MONTICELLO RANCH SUBDIVISION

MASTER DEVELOPMENT PLAN #790B
JULY 2006

Re: Monticello Ranch Subdivision (Amendment)

MDP # 790-B

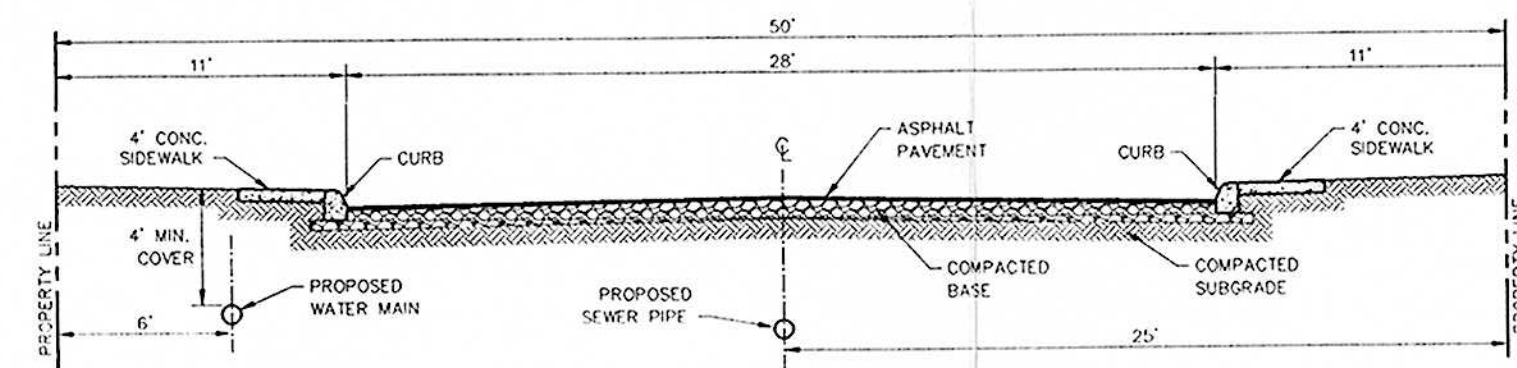
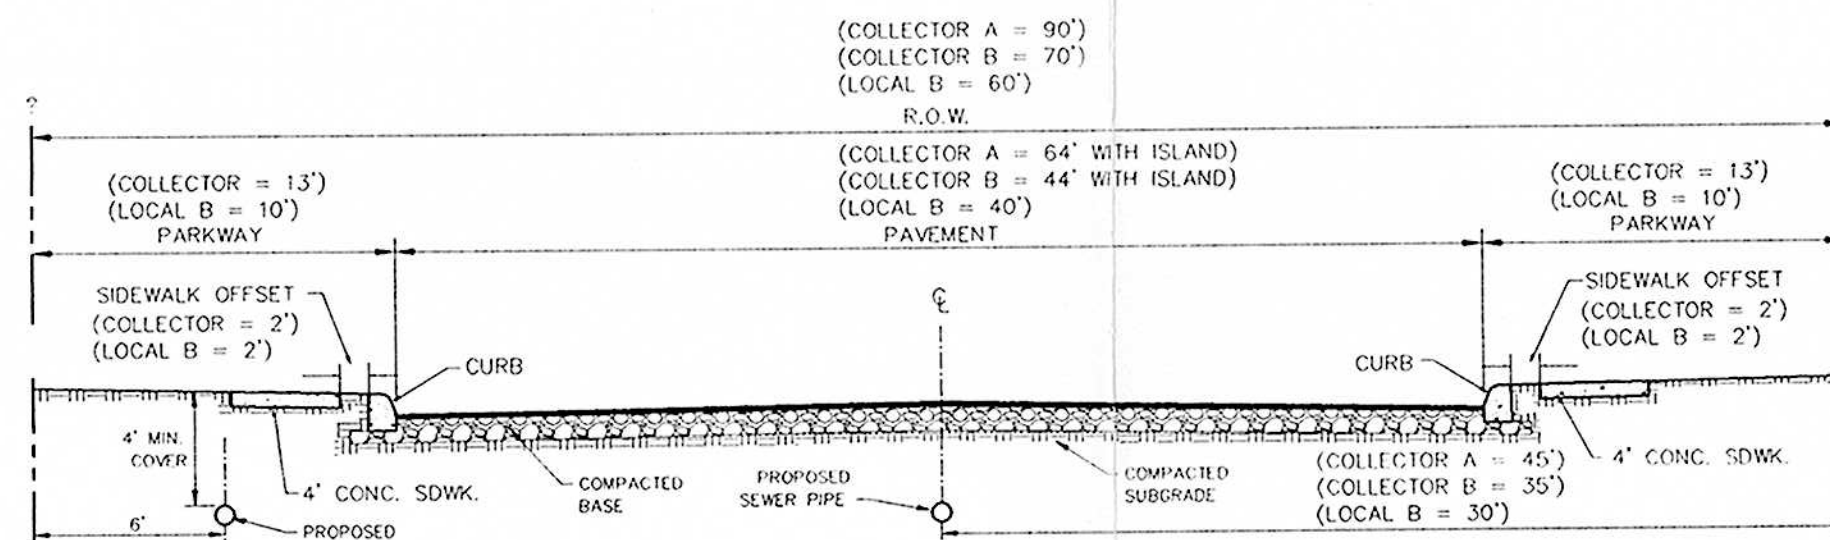
- The acceptance of this Master Development Plan # 790B is confine to the boundary limits of the site. Any projection(s) of future roadways outside the boundaries does not infer any set alignment of future roadways. All major arterials and streets shall follow all regulations.
- In consideration of public safety and convenience, excessive grades by reason of topography should be avoided in street layouts and arrangements.
- Any access and R.O.W. issues along state facilities will need to be resolved with the Texas Department of Transportation (TXDOT). For information about these requirements you can contact TXDOT at 615-5814.
- The above referenced MDP is approved by with the following conditions:

- a. Provide resolution for Street Link that exceeds block length standards in Unit 3.
- b. Provide transition length for change from Local B to Local A in Unit 2.
- c. Evaluate need for detention pond outfall easement.
